Volume : 41 L
Dimensions : 584x390x270 mm
Weight : 14 kg
Rated impedance : 8 Ω
Power handling capacity : 80 W
Cross-over frequencies : 600 - 7000 Hz
Resonance frequency : 54 Hz
Frequency range : 35 - 20.000 Hz

Service Manual

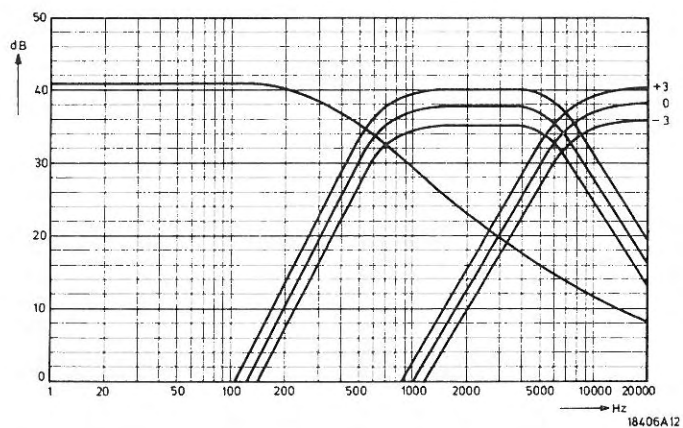
As from PL01032... resistor 802, 3E9 Ω - 7 W, codenumber 4822 113 80182, has been changed to 2E2 Ω - 7 W, codenumber 4822 113 80266.

Resistor 803, 3E3 Ω , codenumber 4822 110 23041 has been changed to 1E5 Ω , codenumber 4822 110 43032.

Clamping grommet 4822 325 80187 has been replaced by grommet 4822 325 80192.

If replacement of clamping grommet is required, always mount a grommet identical to the remaining three or replace all four grommets by new ones !
